From: [Liang You](#)
To: [Lowman, Donald](#)
Cc: [Xu, Shirley](#)
Subject: [External_Sender] Re: REQUEST FOR ADDITIONAL INFORMATION
Date: Friday, December 07, 2018 11:36:25 AM

This email is in response to your application, U.S. Nuclear Regulatory Commission (NRC) Form 313, dated August 20, 2018, requesting an exempt distribution license. We do not have sufficient information to complete the review of your application. Please provide responses to the information request below:

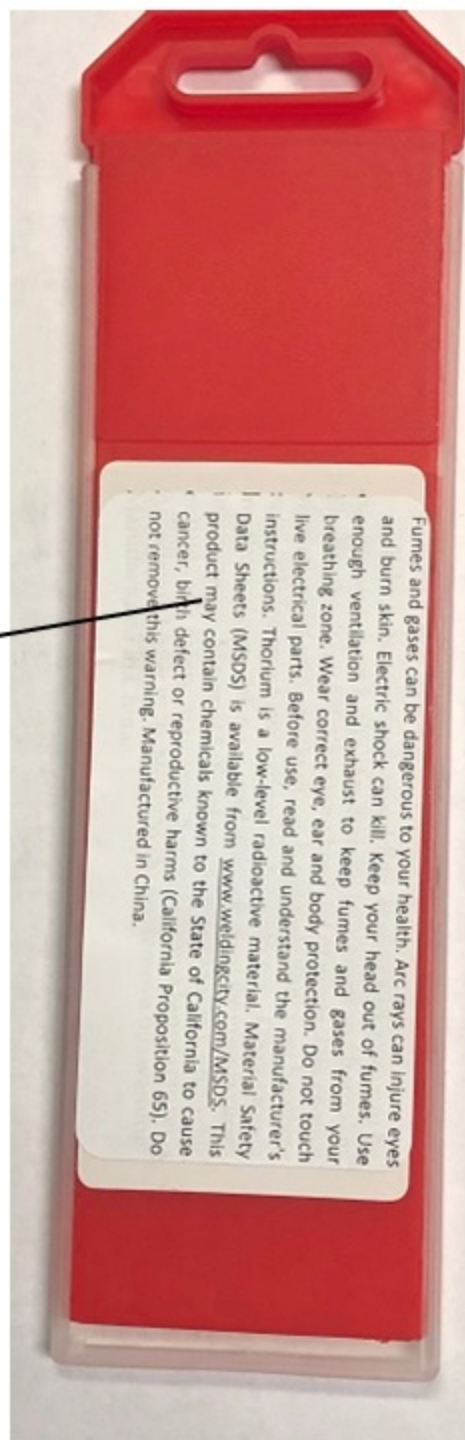
1. Per [10 CFR Part 40.52\(4\)](#), please provide "The proposed method of labeling or marking each unit, and/or its container with the identification of the manufacturer or initial transferor of the product and the source material in the product".

- For your first question, a file "Product_Container" is to provide the details of product labeling (front and back) of the product container. The container box has customer label, content label, radioactive material (2% Thoriated Tungsten) and ANSI/AWS/ISO compliance information/source on the front side. A text label on the box backside is to give safety warning related to product use including general welding operation as well as MSDS' url and warning of California Proposition 65.

Red color box to comply with AWS spec for 2.0% Thorium Tungsten electrodes (Color code: Red).

Box backside to give safety warning related to product use including general welding operation as well as MSDS' url and warning of California Proposition 65

Source material and content labeled

ANSI, AWS and ISO compliance information and resources
